MEMORANDUM

To: Mr. Pete Van Grootheest, Senior Project Manager (BBS Construction)
From: William Sherwin, P.Eng. (Egis) Thomas Gryze, M.A.Sc., P.Eng. (Egis)
Date: August 14, 2024
Re: 1540/1560 Star Top Road Warehousing Development – Road Safety Review

**Re: Redevelopment of 1540 & 1560 Star Top Road, Boone Plumbing & Heating Supply Inc.
Proposed New Warehouse
Preconsultation Feedback Response Submission No. 1
City File No. PC2023-0219**

Drawing
PROPOSED SITE PLAN

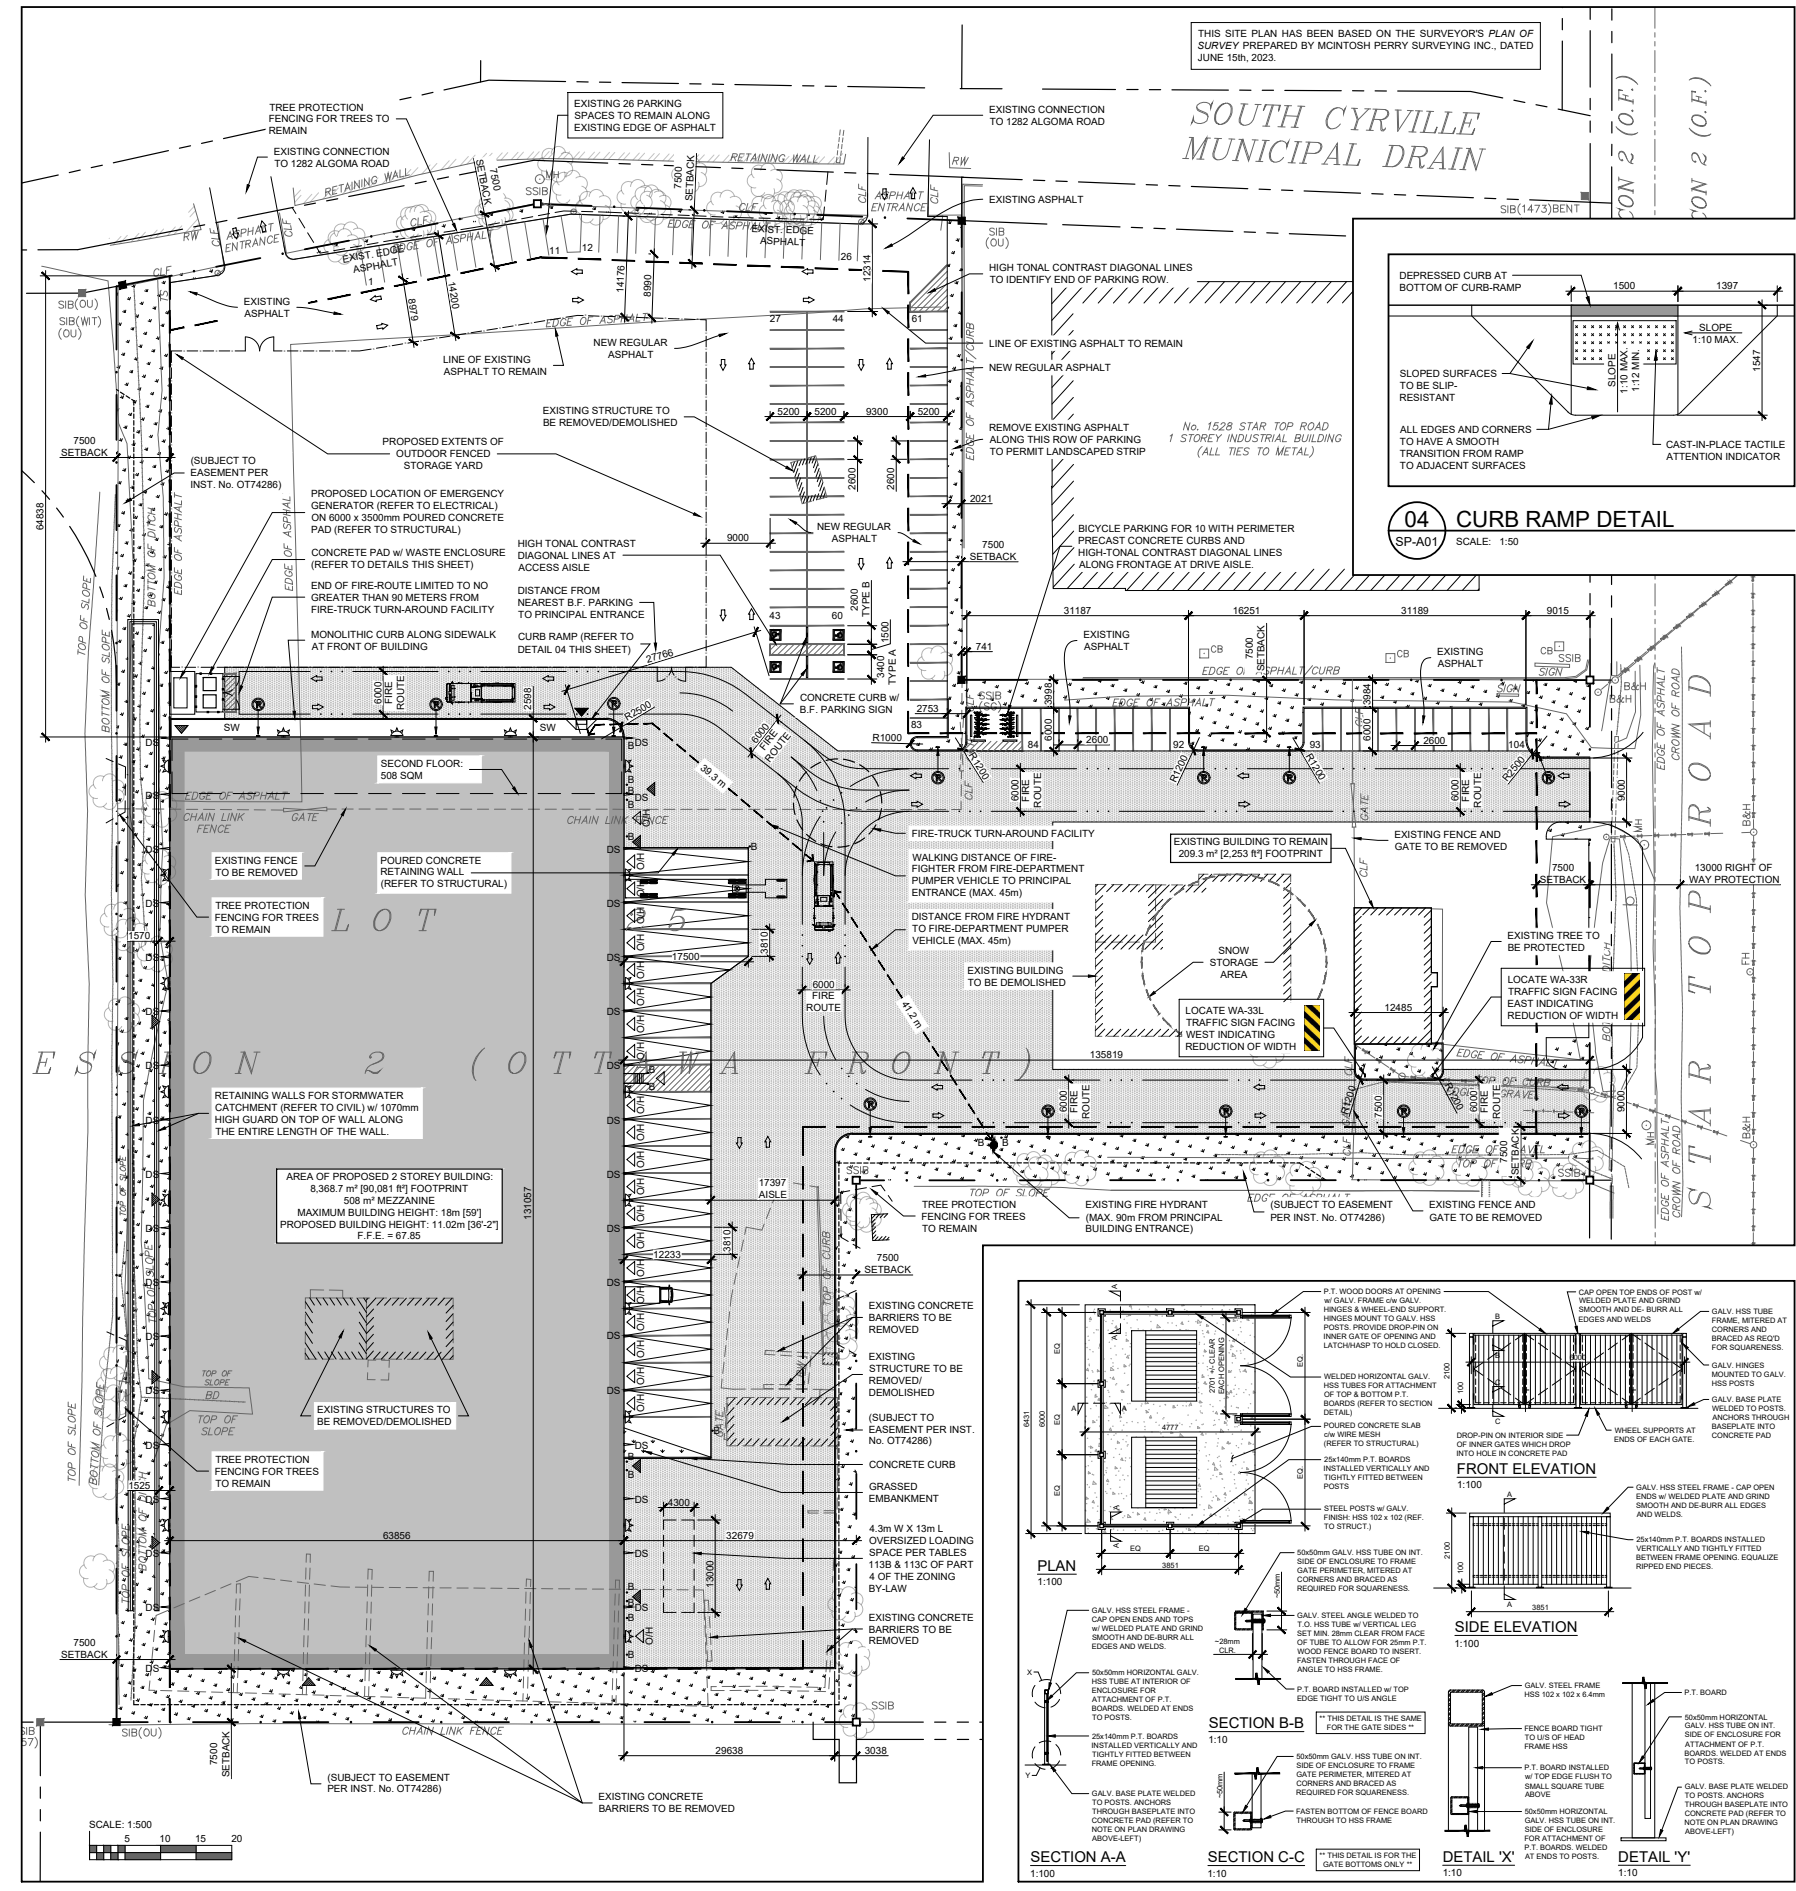
1. The Zoning By-law Checklist has identified deficiencies with the current proposal:
 - a. Please ensure that any proposed sales or display area comply with the provisions of 203(4).
 - b. The IL prohibits outdoor storage as per 203(5) while a large outdoor storage area is being proposed.

REPLY: The proposed outdoor storage area has been removed from the Site Plan at this time.
